TSB170022

Steel Piston and Aluminum Piston Kit Introduction

- ISL G CM2180

Figure 1, Steel Piston Authorized Change Label.

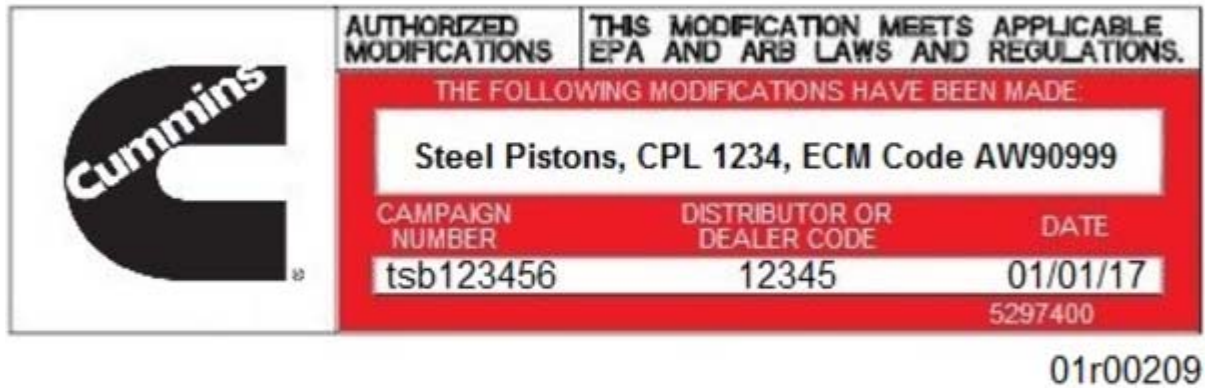
- When changing from aluminum to steel pistons, the CPL number will change.
- Upon completion of the conversion from aluminum to steel pistons, an authorized change label, Part Number 5297400 **must** be completed and installed on the engine. See Figure 1 below.
